**RESOLUTION HOLDING HEARING ON REQUEST FROM HUBBELL REALTY COMPANY (OWNER), REPRESENTED BY CALEB SMITH (OFFICER), FOR REVIEW AND APPROVAL OF PUD FINAL DEVELOPMENT PLAN FOR “GRAY’S STATION PLAT 5 TOWNHOMES AND CLUBHOUSE,” FOR PROPERTY LOCATED IN THE VICINITY OF 1300 TUTTLE STREET**

Communication from the City Plan and Zoning Commission advising that at their February 2, 2023 meeting, the following action was taken regarding a request from Hubbell Realty Company (owner), represented by Caleb Smith (officer), for the following regarding property located in the vicinity of 1300 Tuttle Street:

## STAFF REPORT TO THE PLANNING COMMISSION

### Product 1

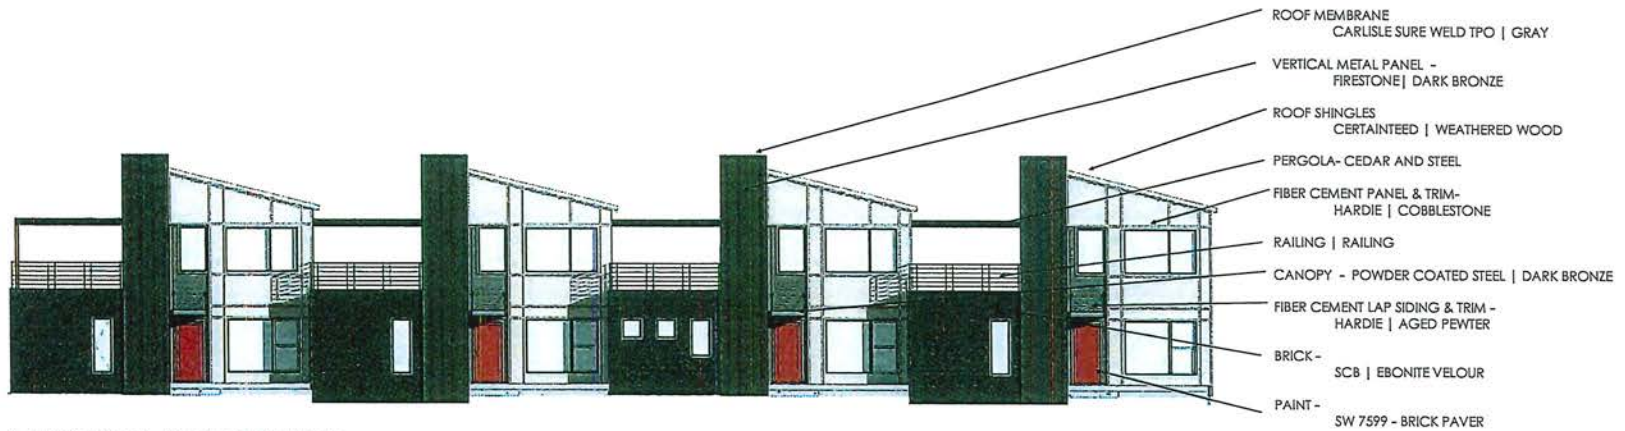
The desire was to create a darker color package for this Product and add some variation between the units.

#### Product 4

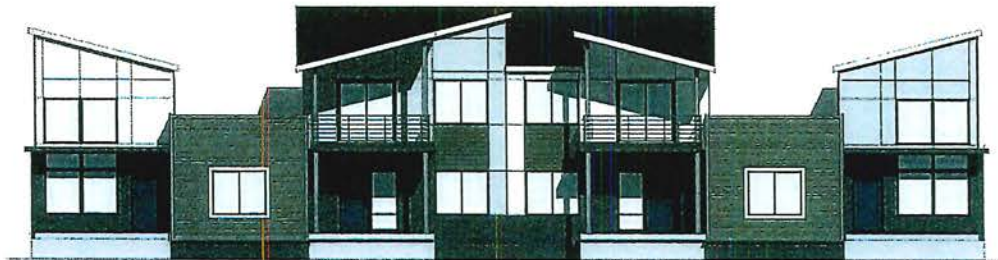
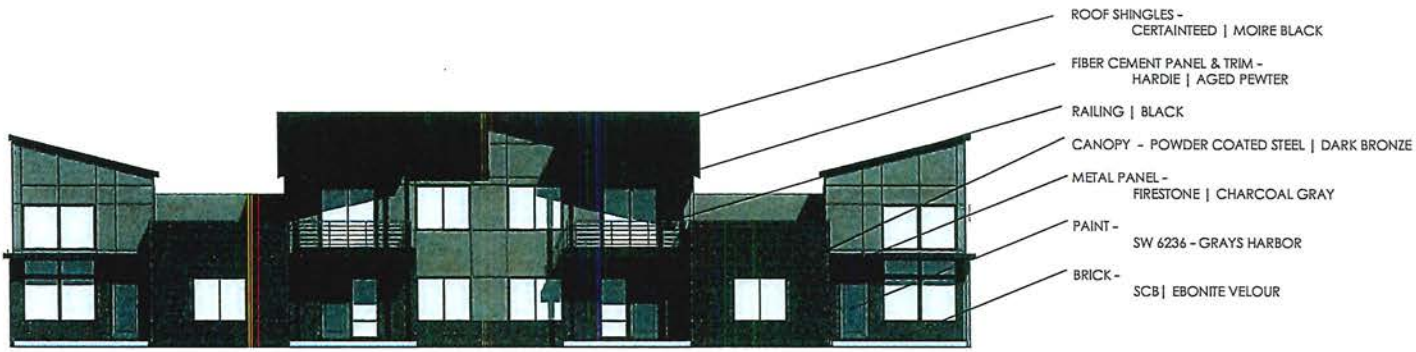
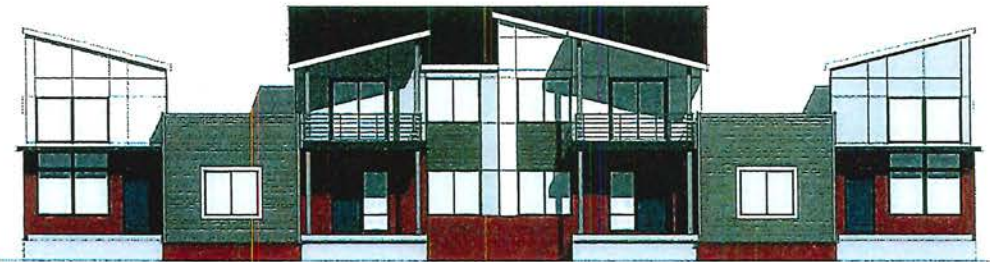
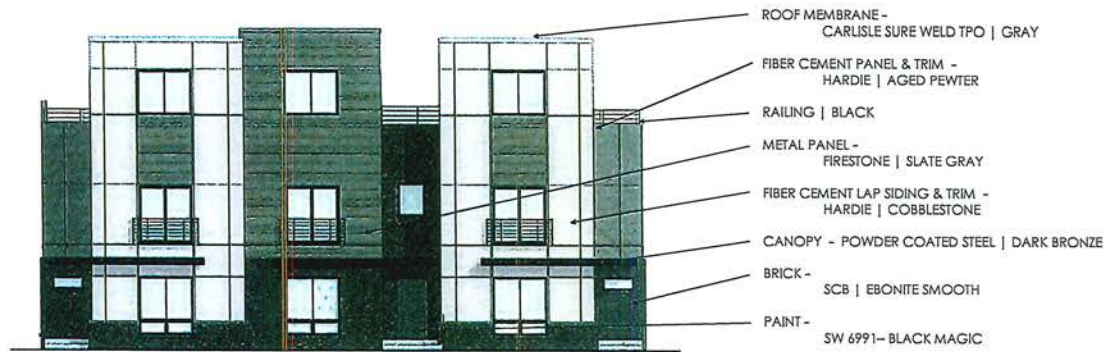
This elevation was too busy and the color scheme too light for this urban environment.

This elevation was too busy and the color scheme too light for this urban environment.

- Changed to a darker color scheme to achieve a more urban look.
- Changed Hardie lap siding on front to metal panels.
- Eliminated the white-colored Hardie panels and matched the panel color on both sides to achieve a unified appearance.
- Steel metal posts will be painted dark gray.

#### Product 6

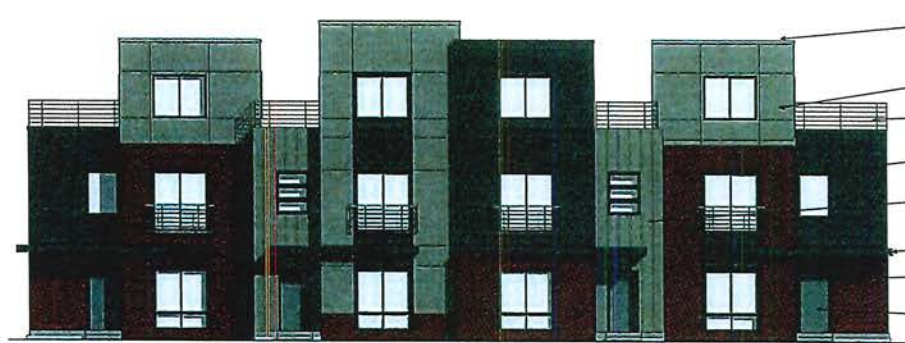
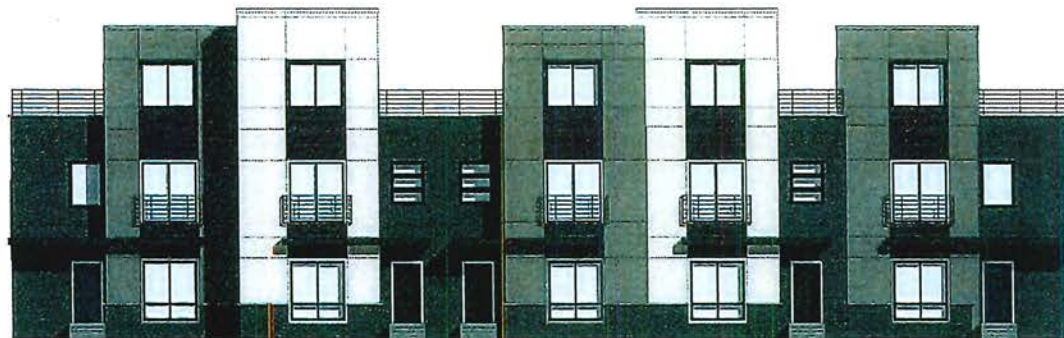
Elevation appeared boring and repetitive. These needed additional visual interest and a more urban look.

- Varied the height of the brick/stone to create diverse building elements and to reduce the repetitive effect of the vertical building elements.
- Introduced building elements sided in metal panels with a vertical pattern.
- Replaced the Hardie panels of one or more of the main building elements with metal panels (horizontal pattern).
- Black windows
- Darkened the color packages
